# US 278 Independent Review

April 2021

The South Carolina Department of Transportation (SCDOT) is proposing to make improvements to the US 278 corridor between Bluffton and Hilton Head Island in Beaufort County, South Carolina. HDR Engineering Inc. of the Carolinas has been tasked to complete an independent review of the ongoing SCDOT study and alternatives for Beaufort County and the Town of Hilton Head Island. The purpose is to review and verify existing documentation, explore additional options, and make recommendations for additional study. In addition, the purpose was to help address specific questions which include:

Figure 2. New Location Alternative to St. Helena Island

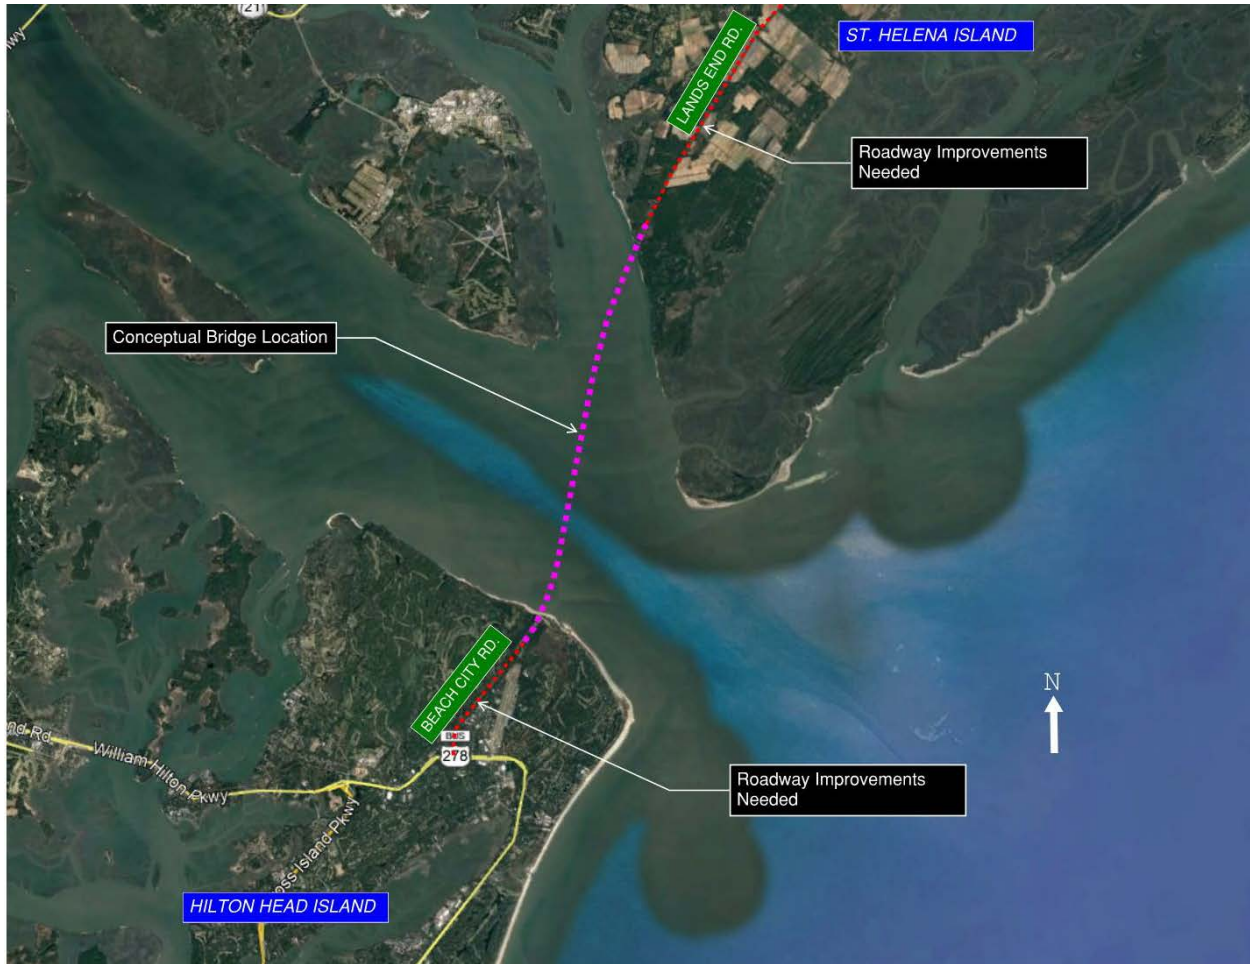
This alternative connects Beach City Road, in the Mitchellville area of Hilton Head Island, with St. Helena Island. This option bridges a deep channel in the Port Royal Sound. While this option connects southern Beaufort County with northern Beaufort County, the road would contribute to additional traffic in the City of Beaufort, which currently has high traffic congestion. To mitigate the additional traffic, improvements would be necessary to Lands End Road. The estimated cost of this project, including the bridge and road improvements on Lands End Road is in the range of \$700 to \$800 million. This type of project would need to be considered as a separate project as it is above and beyond the sales tax referendum description, as well as the State Infrastructure Bank (SIB) application description of improvements.

Alternative 2 provides a direct connection to Hilton Head Island from St. Helena Island, accessing other Beaufort County communities that are otherwise connected via a miles-long route across

Hilton Head Island, the Town of Bluffton and to SC 170 crossing the Broad River into Beaufort. This alternative would also likely have extensive impacts to local communities, Mitchellville at the western end of Beach City Road and Fort Fremont on the east side of St. Helena Island. Roadway improvements and possible mainline relocations of existing facilities may require rights-of-way acquisitions, relocations, and access modifications to residential, commercial, and community/cultural properties. This alternative would also impact pristine beach frontage and access in the Mitchellville area and potentially some areas on St. Helena Island. Costly and time-consuming permitting and mitigation would be required for impacts to wetlands, marshes, and waterways as a result of this alternative.

Figure 3. Impacts to Spanish Wells with Grade-Separated Interchange

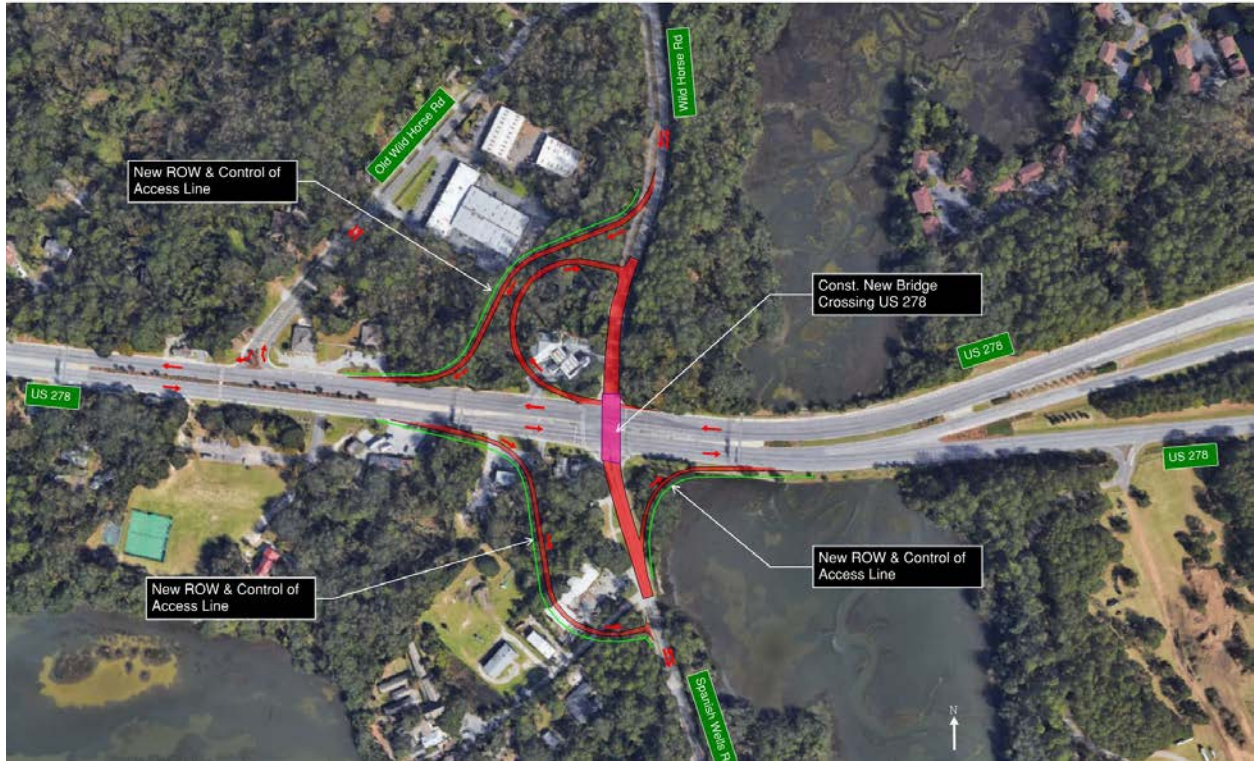
SCDOT had limited information on concepts that allowed for free flow movement of US 278. Concepts include grade-separated interchanges at Spanish Wells and at Squire Pope. HDR sketched some of these options to show the high-level impacts that would be required with full control of access interchanges, reflected in **Figures 3 and 4**. Additional information, to include estimated cost and LOS, should be provided by SCDOT to further document the process of eliminating concepts.

Figure 6. Free Flow Movement Alternative Part 1

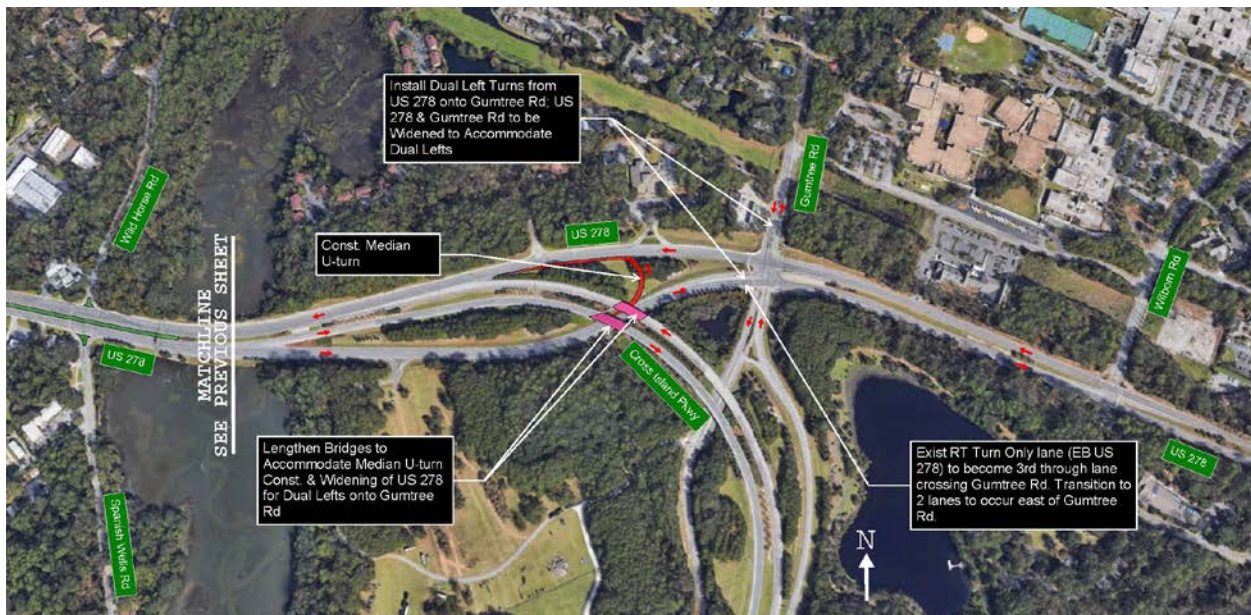
This option removes all signals from US 278 between the bridges and the Cross Island Parkway. This option will require major changes to the Gumtree Road intersection to include a U-turn from eastbound to westbound US 278, dual left turns onto Gumtree Road, as well as new, longer bridges on the Cross Island Parkway over US 278 Business to accommodate turn lanes on US 278 under the bridges. With these improvements, and considering additional traffic using the Cross Island Parkway, the Gumtree Road intersection will still operate as a near failing LOS as well as failing volume to capacity ratio in the 2045 design year. The new travel patterns could mean local traffic may go as far as two additional miles to traverse the same distance as today. At-grade pedestrian cross walks will not be available in this option.

Figure 10. Conventional Intersection Conflict Points

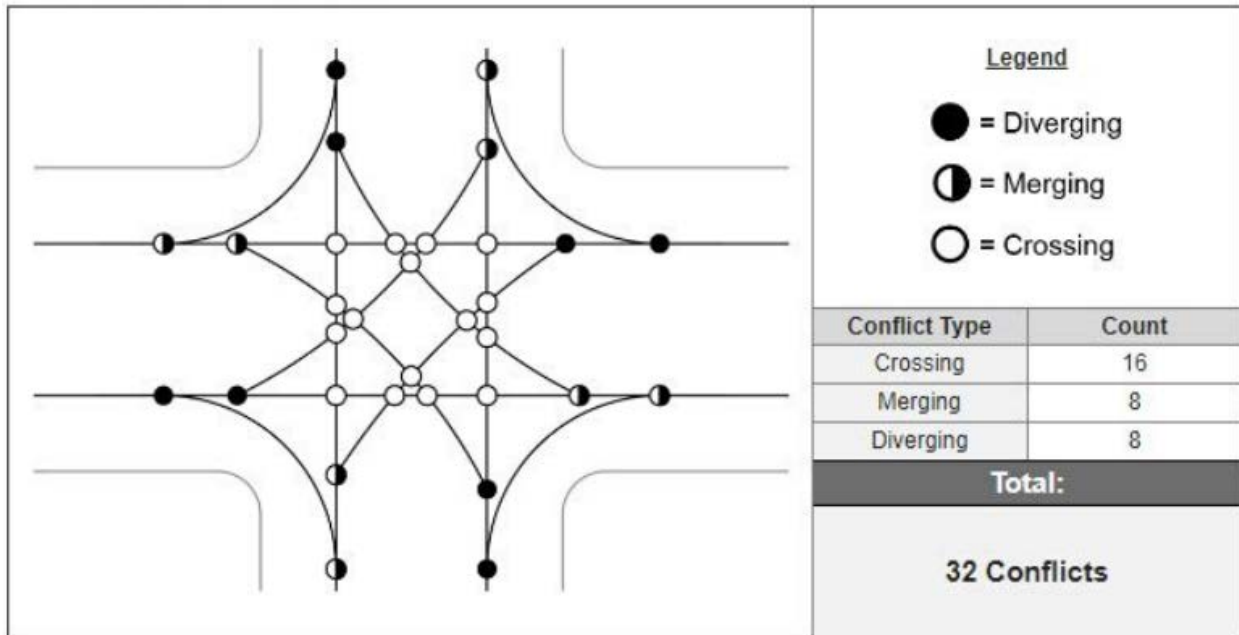
As shown in the crash data, angle crashes are a concern on this corridor. Limiting the number of conflict points will lessen the chance of crashes. HDR recommends alternative intersections, such as signalized U-turns, two-phase signals, and frontage roads that limit conflict points, especially along US 278. This will also decrease the number of phases needed in signals along the corridor.
